POWER PLANT – EEC CHANNEL A AND B – INTRODUCTION OF REVISED ENGINE DEDICATED ALTERNATOR
CONNECTORS – NEW PRODUCTION – CATEGORY CODE 7 – MOD.ENG-71-0200

V2500-ENG-71-0200

Schematic view of part of Loom B - After change
Fig.2

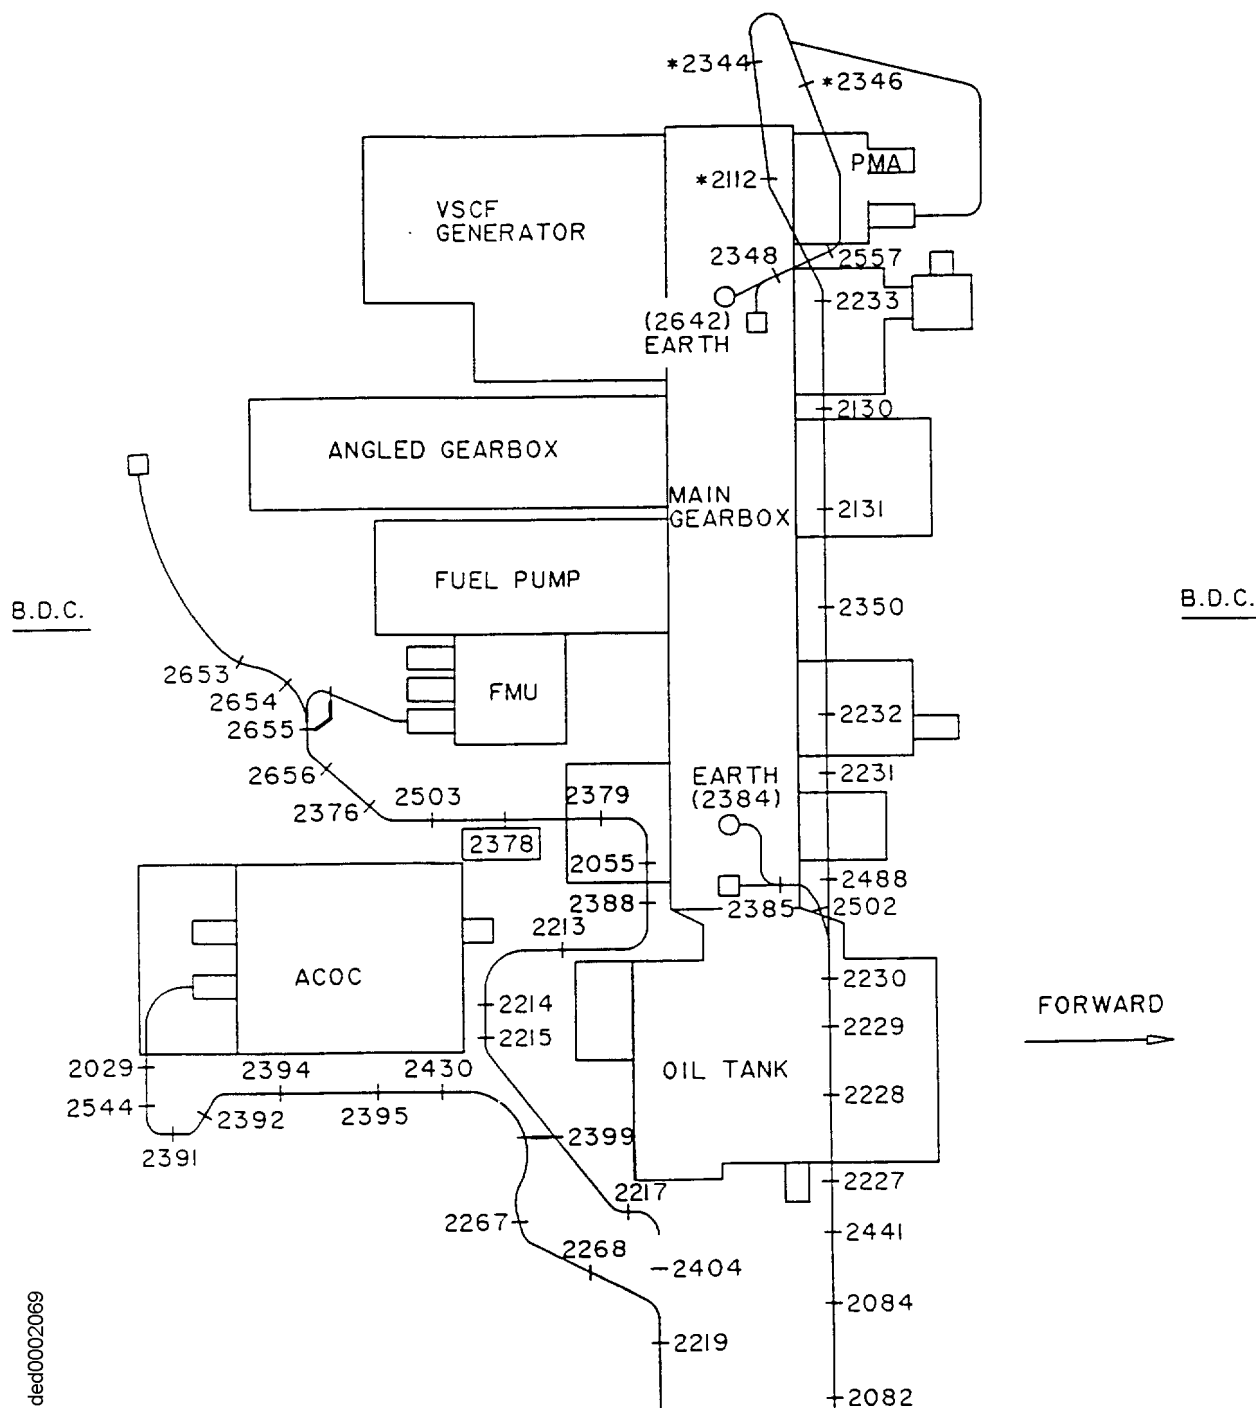
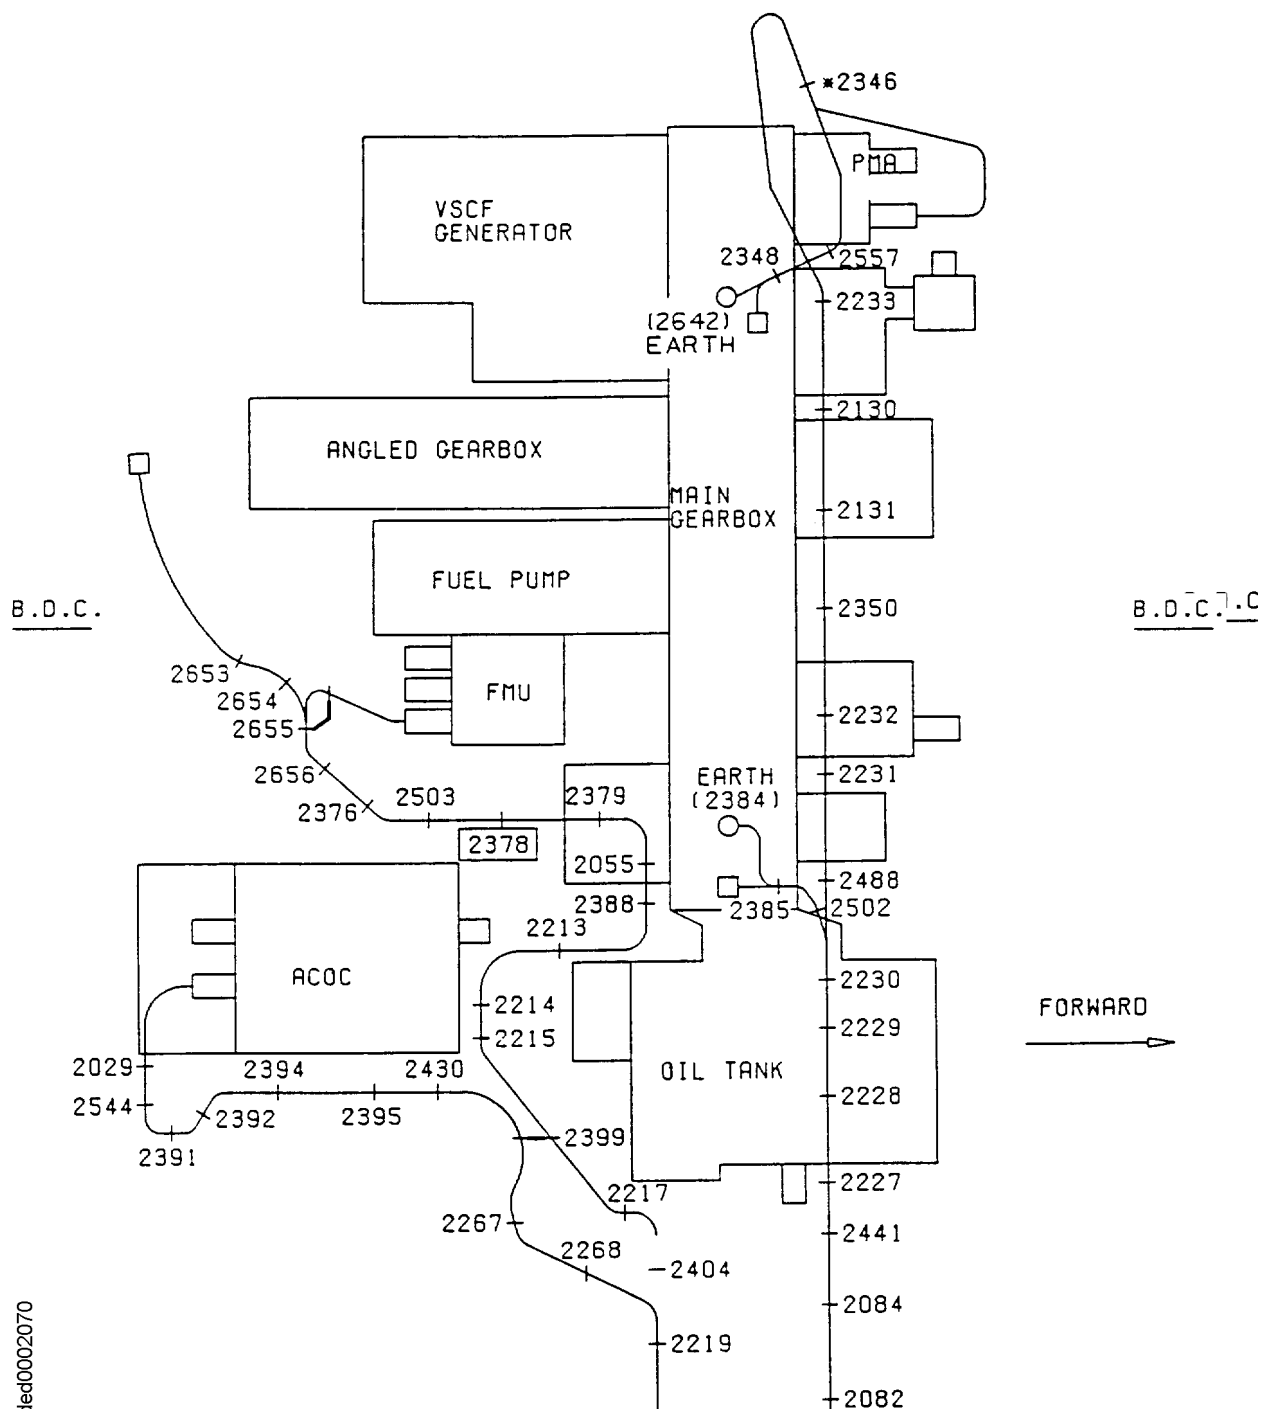
(a) The EEC harness assemblies (Looms A and B) has changed as follows:

- (i) The connector at position P1-8024 (Loom A) and P1-8017 (Loom B) has changed. They have a finer locking mechanism to prevent "Backing-off". The quantity of the contact pins has increased from 10 to 12.
- (ii) The contact sockets have changed so that they connect correctly with pins of the new connector. The quantity of the sockets has increased from 10 to 12.
- (iii) The sealing plugs have changed to make the connector lock better. The quantity of the plugs has increased from two to four.
- (iv) The backshell of connectors P1-8024 (Loom A) and P1-8017 (Loom B) have changed from a straight standard to a right-angle standard.
- (v) The length of the EDA limb of the Loom A has increased to give a better radius and "drip-loop" of cable.
- (vi) The length of the EDA limb and the fire-wire limb (B20) of Loom B has decreased to give a better routing of the harness.

Clip point 2346 - Before and after change
Fig.3

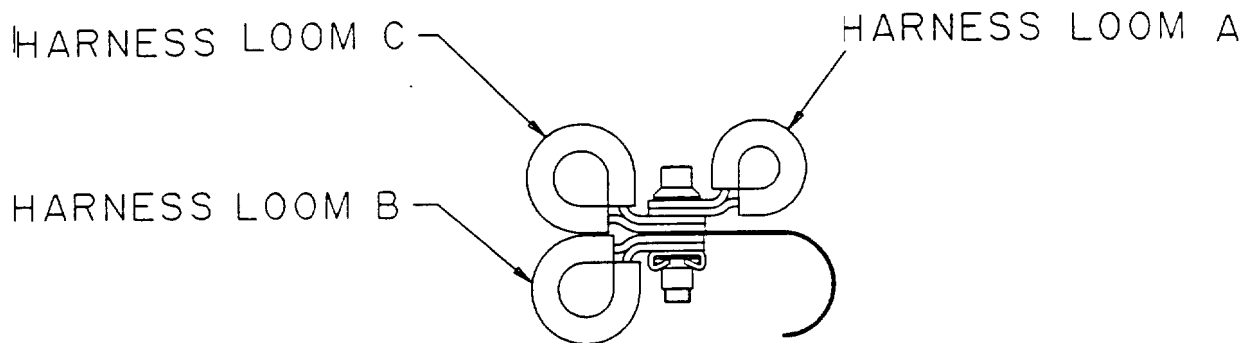
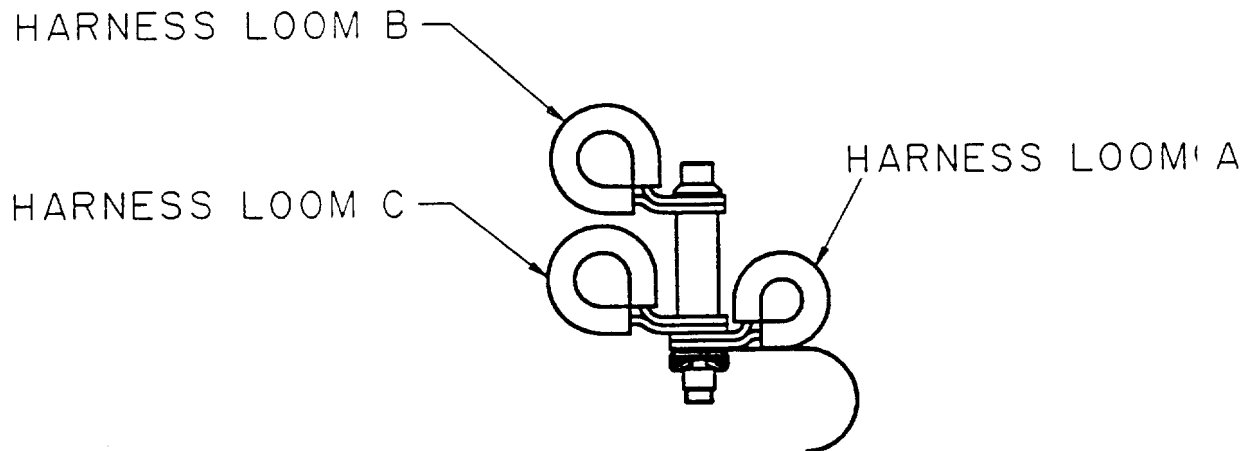
(b) Clip points CP2344 and CP2346 have changed.
